Johnson Creek Floodplain Zoning Code Maintenance

Revising the Johnson Creek Basin Plan District
to Incorporate the Most Current FEMA Flood Maps

Exhibit A: Planning Commission Report and Recommendations to the City Council

Adopted by the Portland City Council
July 9, 2003, Ordinance No. 177689

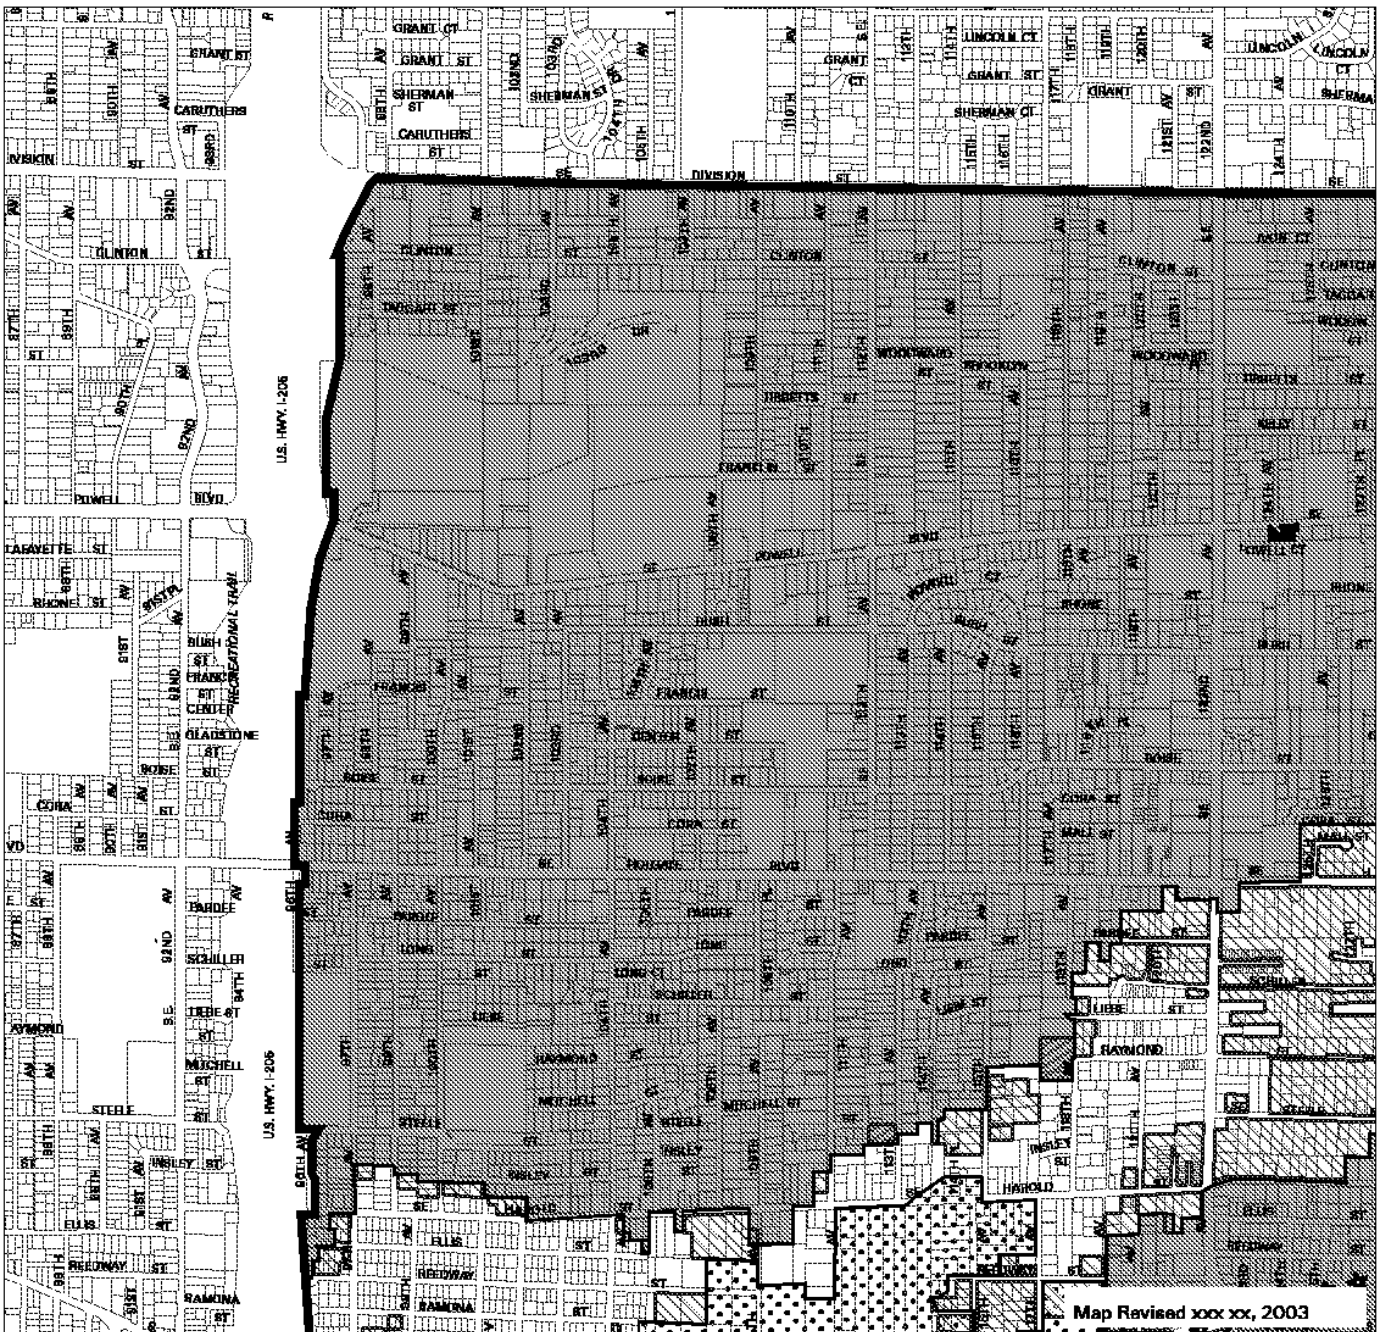
This second set of maps includes additional information to help readers understand the proposals in this report. This information will not be included on the official *Zoning Code* maps. These maps show all the sites that have been removed from, or added to, the floodplain as a result of FEMA's update. The maps also show the Kelly Butte and Johnson Creek Flood Plain subdistricts with a note in the legends that explains that the Johnson Creek Flood Plain subdistrict will no longer be identified on the zoning maps and the Kelly Butte subdistrict will be eliminated.

- LEGEND**
-  Kelly Butte Subdistrict (Subdistrict to be Eliminated)
 -  Johnson Creek Flood Plain Subdistrict (No longer to be mapped)
 -  South Subdistrict
 -  Flood Risk Area
 -  Areas no longer regulated by Floodplain Subdistrict
 -  Additional areas to be regulated by Floodplain Subdistrict
 -  Amended South Subdistrict Boundary

Map 2 of 8

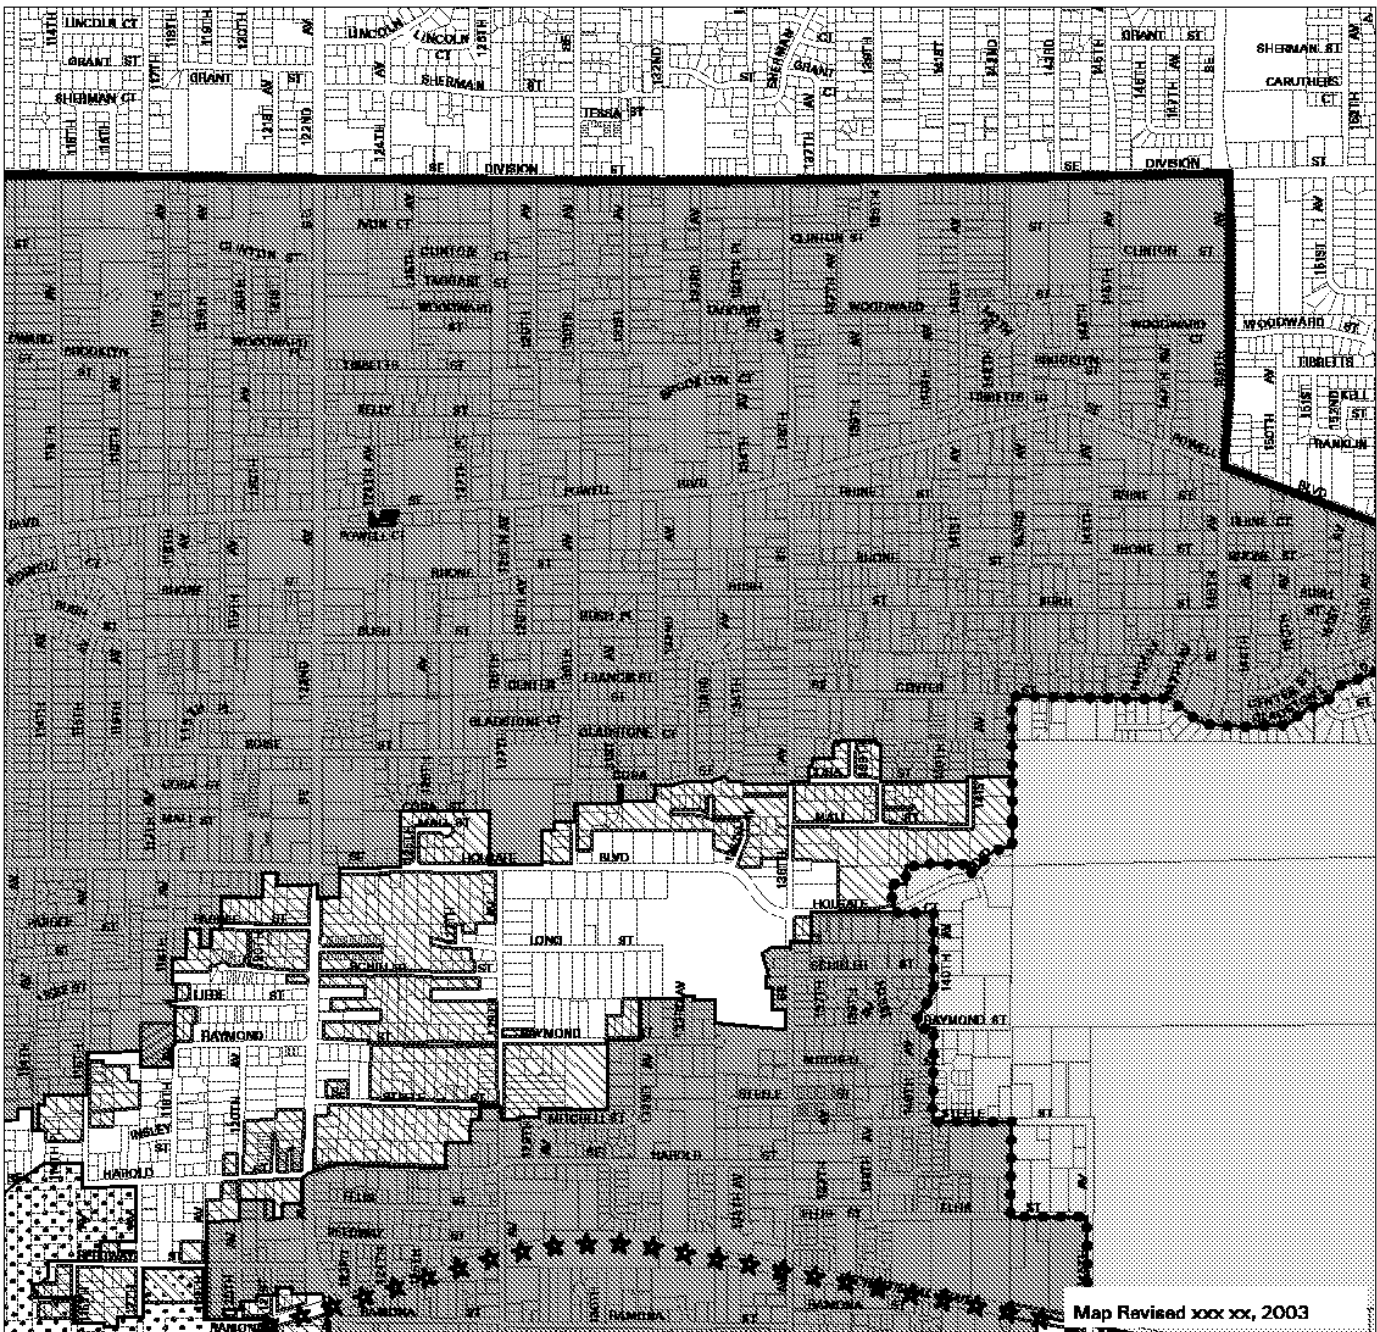
-  Kelly Butte Subdistrict
(Subdistrict to be Eliminated)
-  Johnson Creek Flood Plain Subdistrict
(No longer to be mapped)
-  South Subdistrict
-  Flood Risk Area
-  Areas no longer regulated by Floodplain Subdistrict
-  Additional areas to be regulated by Floodplain Subdistrict
-  Amended South Subdistrict Boundary

Map 631-1
Potential Flood Hazard
Area Map
Proposed Changes

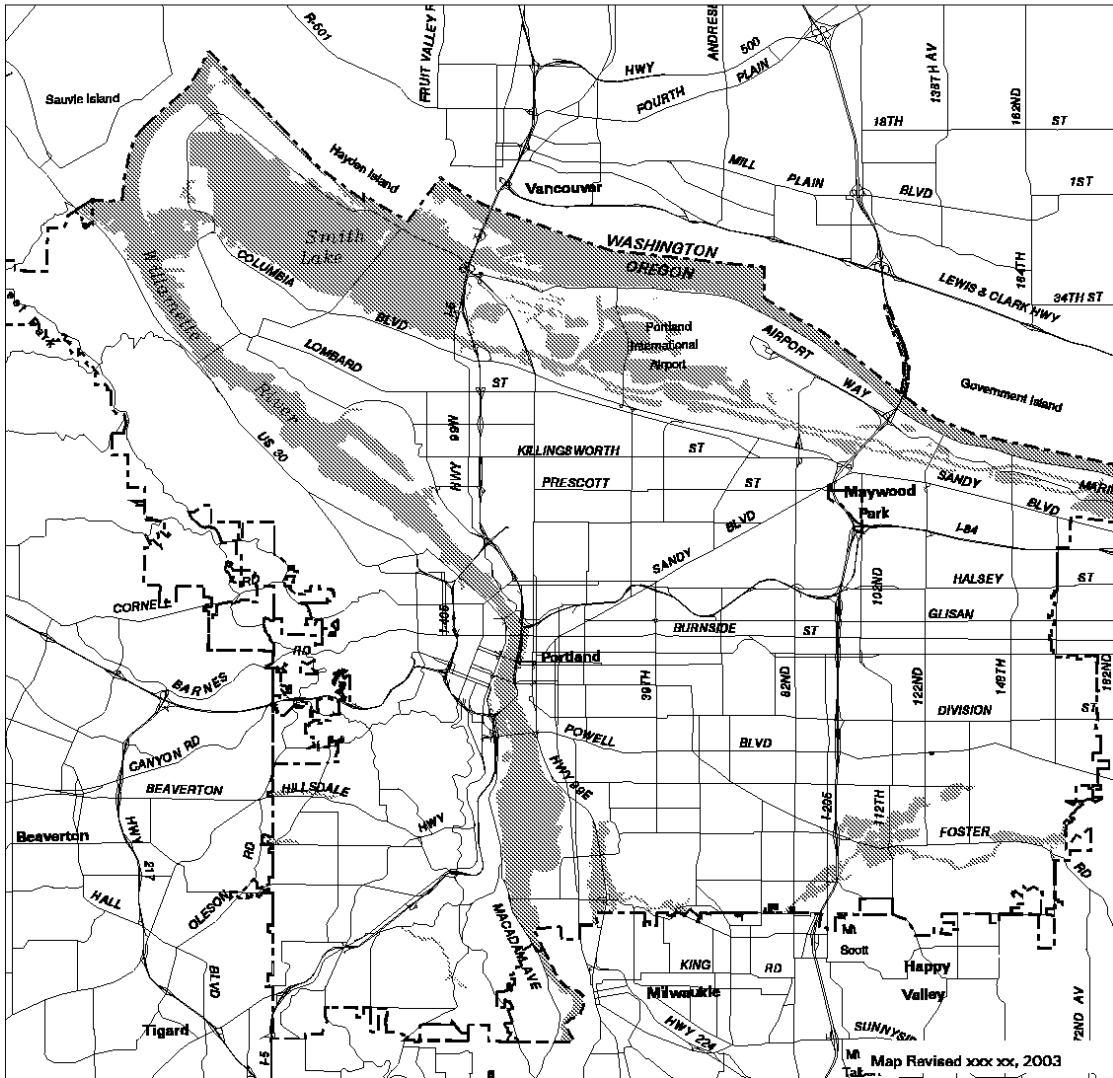
Map 631-1, Potential Flood Hazard Area Map has been revised to reflect the updated FEMA 100-year floodplain boundary in the Johnson Creek watershed. In the Johnson Creek watershed, the 100-year floodplain boundary was the criteria for determining the boundaries of the potential flood hazard area. The amendments to Map 631-1 only affect the Johnson Creek watershed.
